REDTAIL RANCH

PRELIMINARY PLAN

LETTER OF INTENT

DECEMBER 2018

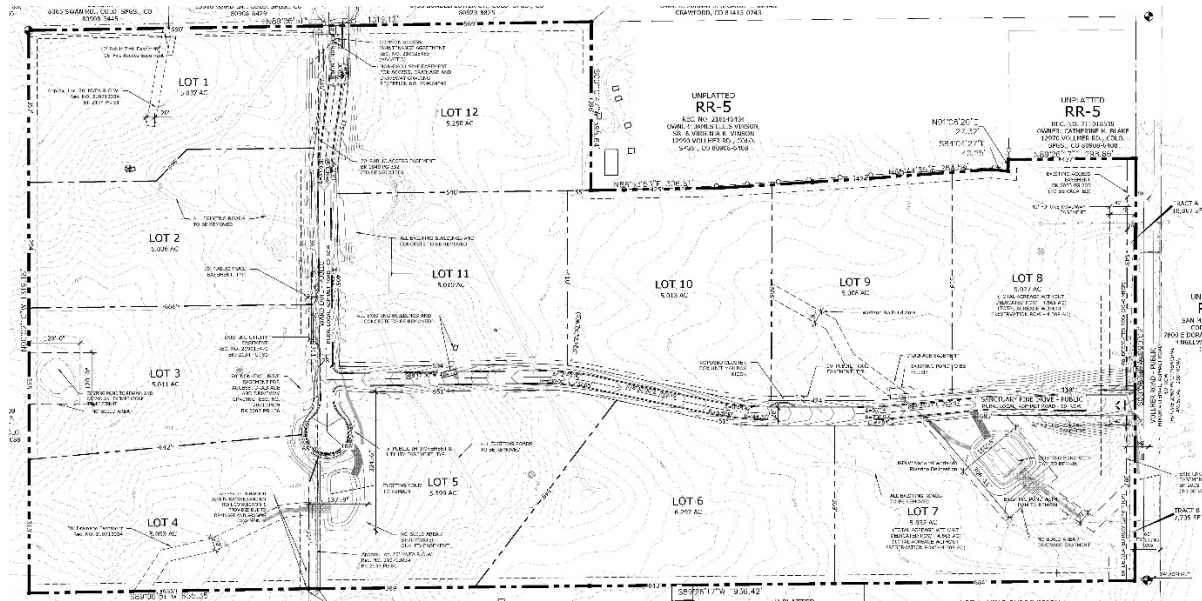
Verify lot area after
row dedication (not
easement)

Verify lot area after row dedication (not easement)
